DECISION, FINDINGS OF FACT AND CONCLUSIONARY FINDINGS OF THE MCMINNVILLE HISTORIC LANDMARKS COMMITTEE FOR THE APPROVAL OF ALTERATIONS TO A HISTORIC LANDMARK LOCATED AT 806 SE DAVIS STREET

- DOCKET:** HL 4-20 (Certificate of Approval for Alteration)
- REQUEST:** Approval of alterations to an existing historic landmark and building that is listed on the McMinnville Historic Resources Inventory as a “Significant” historic resource (resource number B540). The proposed alterations include the removal of two non-original additions on the rear of the structure, removal of an existing exterior chimney, and relocation of windows and doors on the rear façade where the additions are proposed to be removed.

- LOCATION:** 806 SE Davis Street. The property identified as Tax Lot 1100, Section 21CC, T. 4 S., R. 4 W., W.M.
- ZONING:** R-4 (Multiple Family Residential)

The proposed alterations are identified in the submitted building elevations identified below:

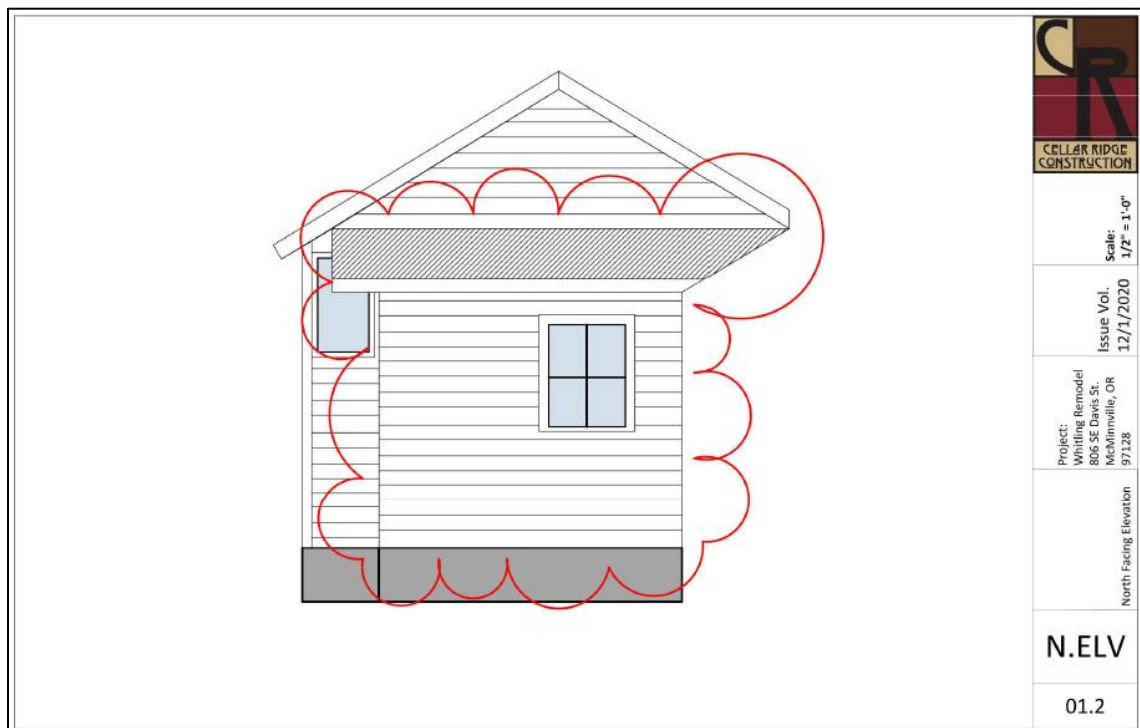
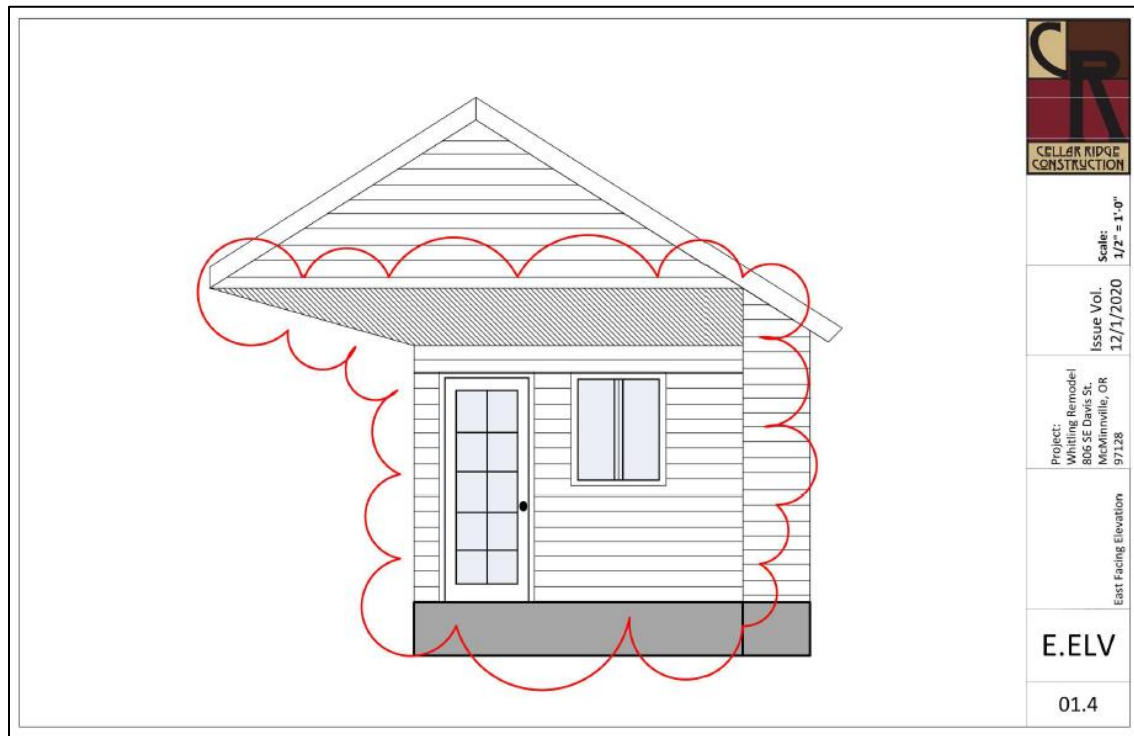
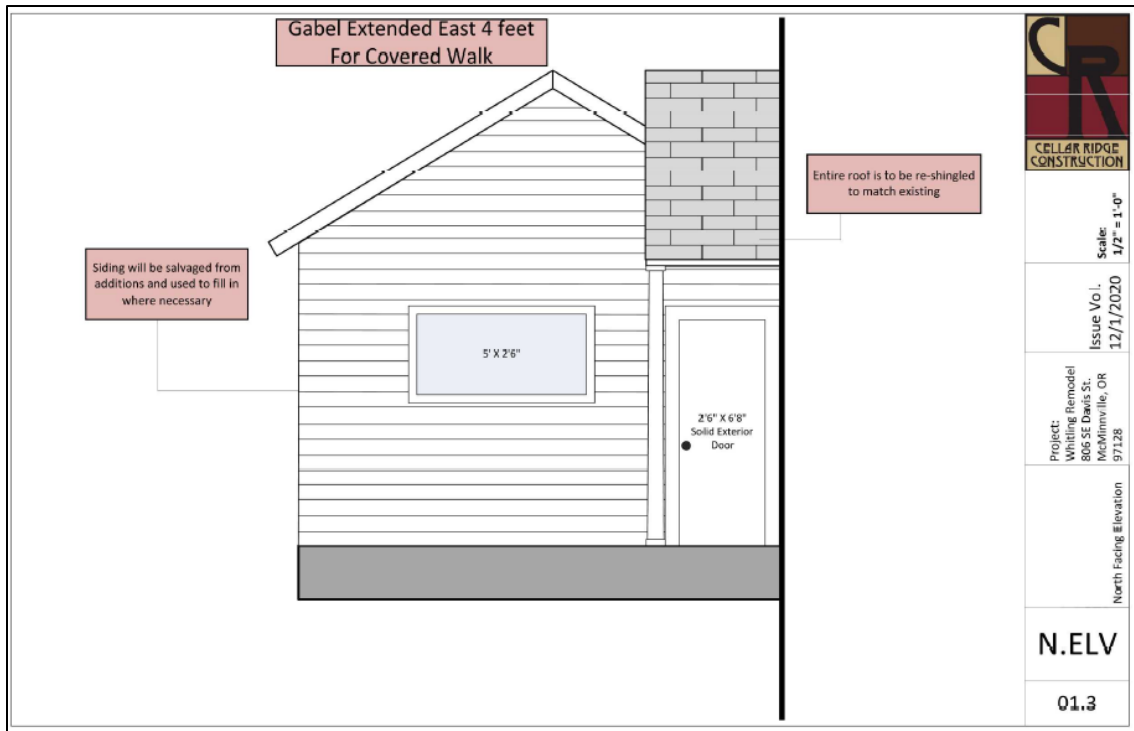
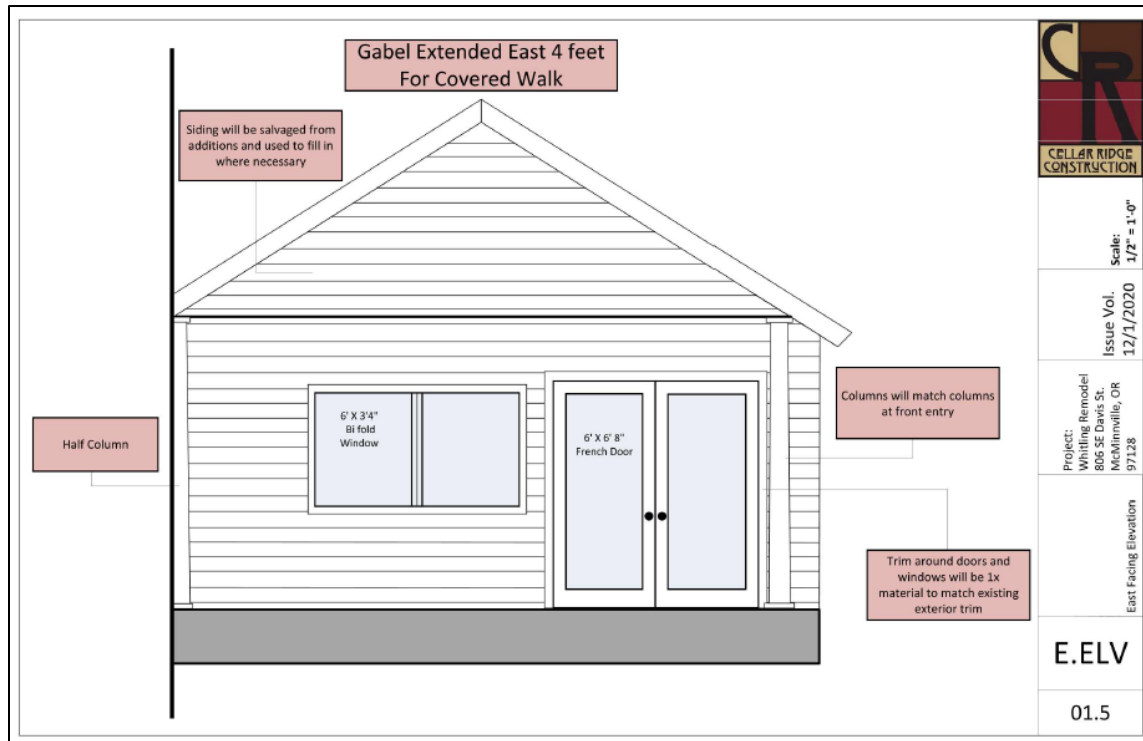
FINDING: SATISFIED WITH CONDITIONS #1, #2, AND #3. The City partially concurs with the applicant's findings. The City finds that evidence was provided to support the proposed removal of the porch additions, based on evidence that they were added at a later date and not original to the building or property. The porch additions are not associated with the documented historic character of the property and therefore, their removal does not result in the loss of a feature or space that characterizes the property. The footprint of the historic building after their removal will more closely resemble the original footprint and form of the building.

The exterior of the building, after the removal of the porch additions, is also proposed to be altered. The original east facing façade, as it exists underneath the existing porch addition, will be altered by the relocation of the door and enlargement of the door opening for French doors. The east facing façade will also include a new opening for a new window, and is also proposed to include an extension of the gable roof to allow for a small covered area underneath the extension of the gable roofline. The north facing façade, as it exists underneath the existing porch addition, will be altered by the replacement of the existing door, the removal of one small window, and the addition of a new window more centrally located within this north facing façade.

The City finds that the proposed removal of the exterior chimney is not supported, and that the removal of this feature would result in the loss of historic character of the building. While the chimney is not specifically referenced in the Historic Resources Inventory description of the historic resource, the chimney appears to be original and therefore provides historic character as an original feature still made of original brick materials. No evidence was provided that the chimney on the exterior of the building is in poor condition that would warrant its removal, but the chimney is proposed to be removed because the fireplace on the interior of the structure is being removed. The City does not find that this warrants removal of the exterior chimney. In order to preserve this original feature, a condition of approval is included to require that the exterior chimney be supported and maintained during the removal of the interior fireplace. If the exterior chimney is not able to be supported during the removal of the interior fireplace, the chimney shall be reconstructed on the exterior of the home using the salvage brick material if possible, or compatible replacement bricks if necessary due to loss of bricks during dismantling and reconstruction. The replacement chimney may be constructed with wood framing and a thin brick veneer, with the replacement brick being as similar in color to the original as possible.

However, the proposed window and door materials are not found to be physically or visually compatible with the historic resource, and also are not found to be consistent with other applicable review criteria, as described in more detail below. Conditions of approval are included to address the window and door materials.

FINDING: SATISFIED WITH CONDITIONS #1, #2, AND #3. The City partially concurs with the applicant’s findings, in that the proposed alterations do not impact historically significant portions of the historic resource. However, the City finds that the proposed material for the windows and doors did not satisfy other applicable review criteria, as described in more detail above and below. Conditions of approval are included to address the window and door materials, as well as the siding, window trim, and the chimney. These conditions of approval will ensure that the finishes associated with the alterations will match the existing materials and finishes on the historic building. The condition related to the window and door trim does specify that the more decorative exterior window headers that exist on the front building façade do not need to be included in the window and door trim associated with the new windows and doors, since they are on a rear façade and not including that decorative finish will distinguish the new windows and doors from the old.

1. That the new windows and doors be wood to be consistent with the historic materials that existed on the historic resource and to protect the historic character of the historic resource. The windows and doors shall be finished with wood trim that matches the size and dimension of the existing window trim on the remainder of the house. The more decorative exterior window headers that exist on the front building façade do not need to be included in the window and door trim associated with the new windows and doors.

2. That the siding on all final exterior building facades be a wood, horizontal siding that is consistent with the siding on the remainder of the home. As stated in the application narrative, the applicant shall attempt to save any matching siding from the porch additions being removed to be used in the final exterior building facades.

3. That the exterior chimney be supported and maintained during the removal of the interior fireplace. If the exterior chimney is not able to be supported during the removal of the interior fireplace, the chimney shall be reconstructed on the exterior of the home using the salvaged

4. That the rear porch columns and siding shall match the configuration of the front porch columns and siding.

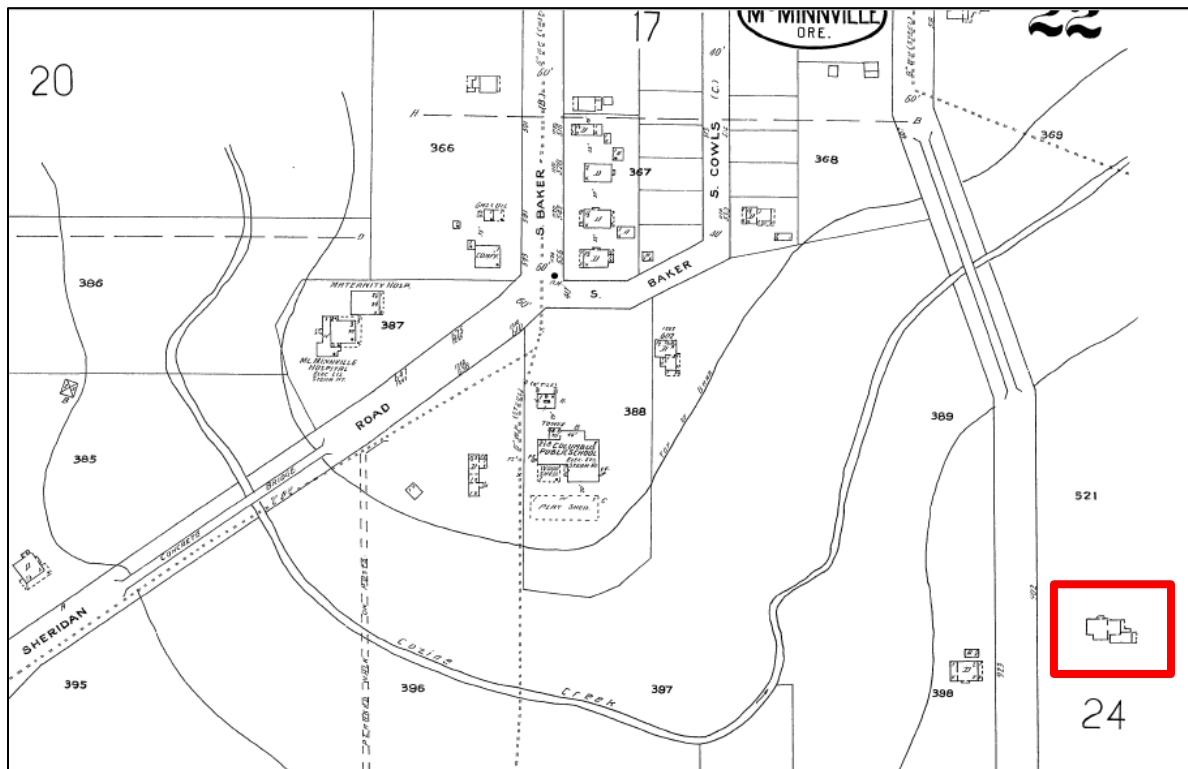
- Interior walls of these two rooms consist of exterior siding that matches the rest of the house. (Figure 2)
- The floor of these rooms slopes away from the main structure, consistent with original use as a porch.

- A screen door is still attached and in use between the kitchen and porch structure, despite the fact that this doorway is fully enclosed within the interior of the home. (Figure 3)

- Evidence of a prior large exterior window on the East-facing interior wall clearly shows that this was previously an exterior wall of the home. (Figure 4)

- A close look at the ceiling of the porch structure shows that the original roof line and decorative elements of the main structure were preserved, and the walls and ceiling of the porch structures were simply notched to accommodate the shape of the roofline. (Figure 5)

- Seams between the existing main structure and the walls of the porch additions are quite open and daylight is readily visible between them. Pattern of siding is also offset from that of the main house, neither of which would be expected if construction of the two were contemporaneous. (Figure 6) [...]

FINDING: SATISFIED WITH CONDITION #3. The City concurs with the applicant’s findings, in that there is no evidence that the porch additions, which were changes to the property, have acquired historic significance that require retention or preservation. However, the removal of the chimney was not found to be supported by other applicable review criteria, as described in

1928 Sanborn Map – Sheet 22:

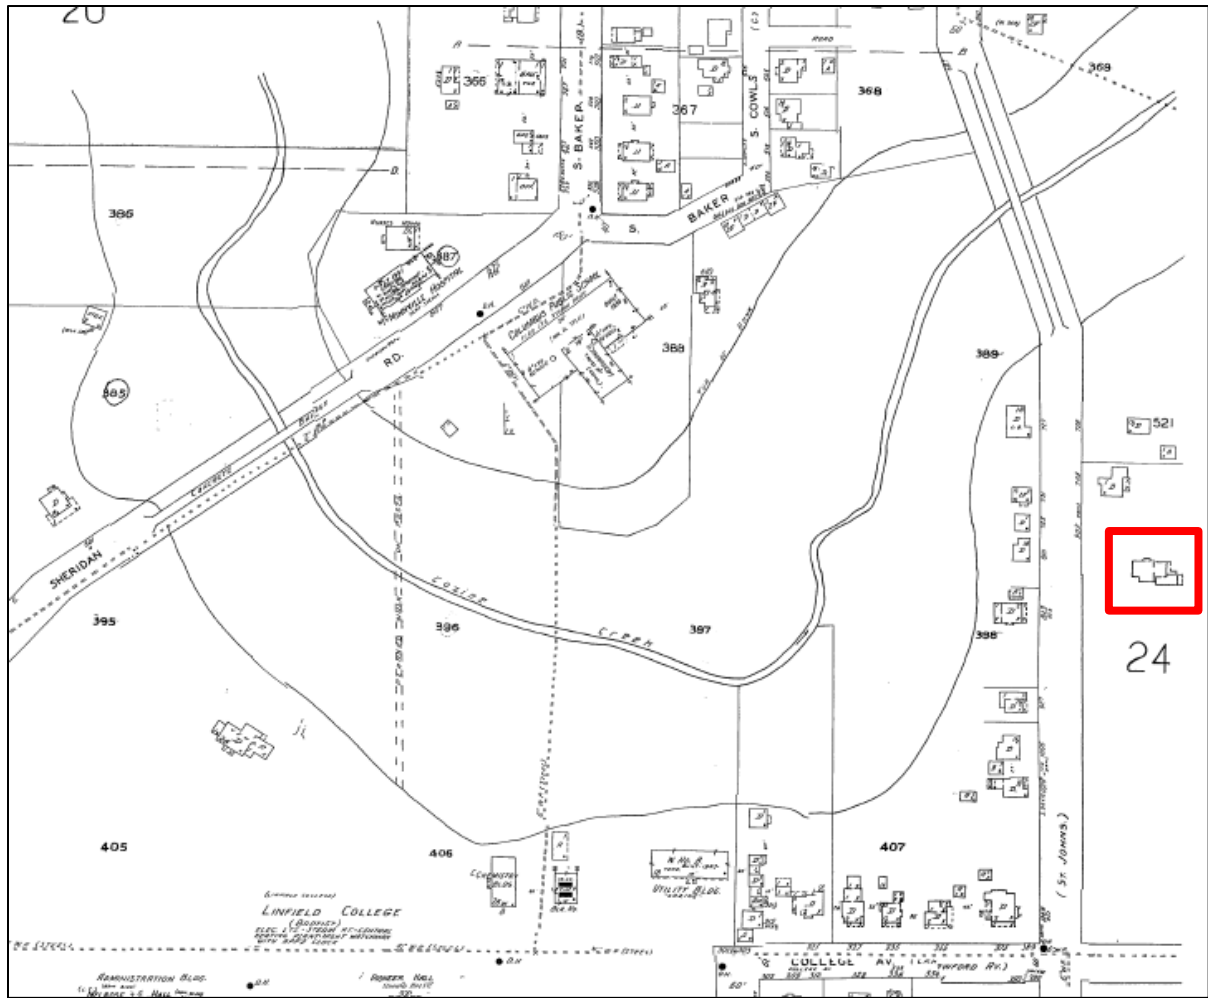
Sanborn maps were reviewed in order to determine whether the additions proposed for removal were original to the building. The first Sanborn map that identifies the area where the subject historic resource is located was in 1928. The historic resource appears to be shown on the 1928 Sanborn map. However, not much detail is provided for the structure, if it is the historic resource in question. The area and the same structure are shown again on the 1948 Sanborn map, but again not much detail is provided for the structure. If these structures on the Sanborn map are the historic resource in question, the porch additions were not original. The exiting garage south of the main home is also not original, which is consistent with the existing floor plan that shows the garage being attached to a later addition. Based on the Sanborn maps and the evidence provided by the applicant, it is determined that the additions proposed to be removed are not original. The Sanborn maps and the potential reference to the historic resource at 806 SE Davis Street are identified below.

Finding: Based on evidence provided by the applicant and an analysis of Sanborn maps that identify the historic resource in question, the City has determined that the proposed removal of the existing porch additions is appropriate. This determination is based on the fact that the additions are not original to the structure, are in areas of the building that are on the rear building facades in locations that are not prominent or highly visible, and are also in an area of the building that is not specifically referenced in the statement of historical significance in the Historic Resources Inventory sheet for the structure. Therefore, the removal of these additions will not detract from the historic character of the site and do not result in the removal of a building feature that is important in defining the historic character of the site.
